Council Meeting - Agenda Item 9.2 - Attachment 5
Response to Representations
58 and 60 Galvin Street South Launceston - 18 November 2021

DA0541/2021 – RESPONSE TO REPRESENTATIONS
60 GALVIN STREET, SOUTH LAUNCESTON 7249

Figure 2 - Townhouse Eastern Elevation - Window shown in blue circle

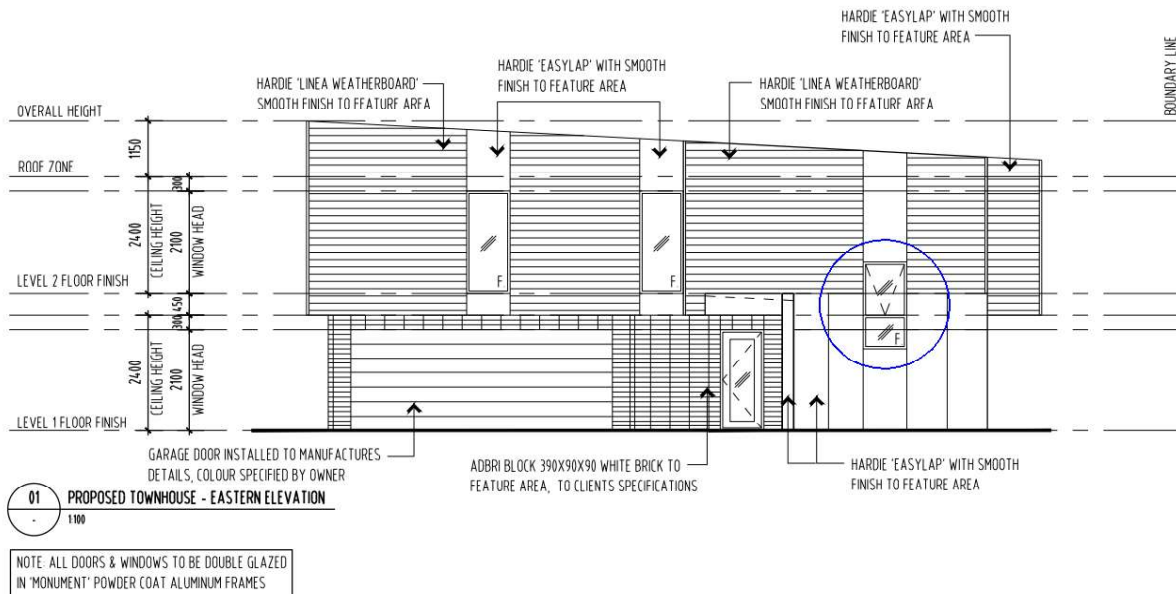
The representation raises concerns of overshadowing and overlooking into their property, that due to the explanation within the representation (that the John Galvin School covered play area overshadows their backyard) can reasonably be assumed to be 20 Mulgrave Street.

Response to Overlooking

Clause 11.4.13 within the planning scheme address overlooking requirements. The proposed development contains only one window on the eastern wall of the townhouse adjacent to the subject property, that is within the stair landing between the ground and first floors (refer Figure 2 – note other windows are not adjacent to the boundary). Although 20 Mulgrave street has a higher elevation than the proposed window and there is significant vegetation providing a natural screen between the two properties, I would be content for an approved development application to include a condition to have fixed, obscure glazing in any part of that window less than 1.7m above floor level; meeting acceptable solution A1.1 (c).

Figure 3 - Existing House - Southern Elevation

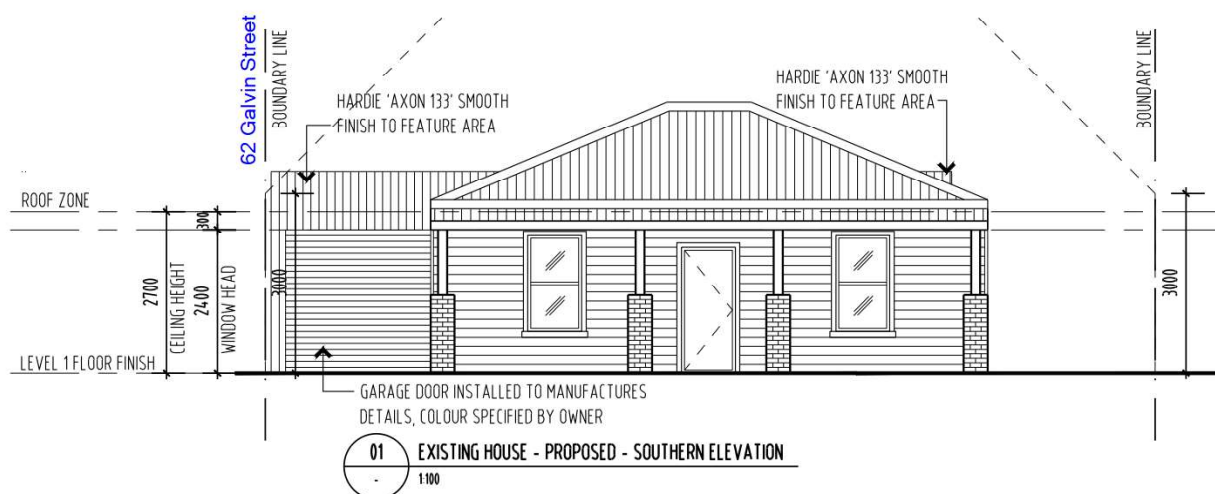
- The development is not within the building envelope,
- There is significant reduction of sunlight and increased overshadowing onto both 62's private open space and 62A's main rooms and private open space,
- The accuracy of the shadow diagrams,
- The compatibility with the streetscape and impact on the amenity of nearby uses,
- The proposed 1.8m fence between 62 and 60 Galvin Street, and
- Overlooking into the school grounds.

Response to Building Envelope

Figure 3 and Figure 4 show the southern elevations of the proposed extension and townhouse respectively and their impact on the building envelope, shown by the dashed line. The figures show that only the very tip of the garage and townhouse parapet (which is only at the southern end due to the roof line failing away to the north) extend beyond the building envelope on the 62 Galvin side of the dwellings.
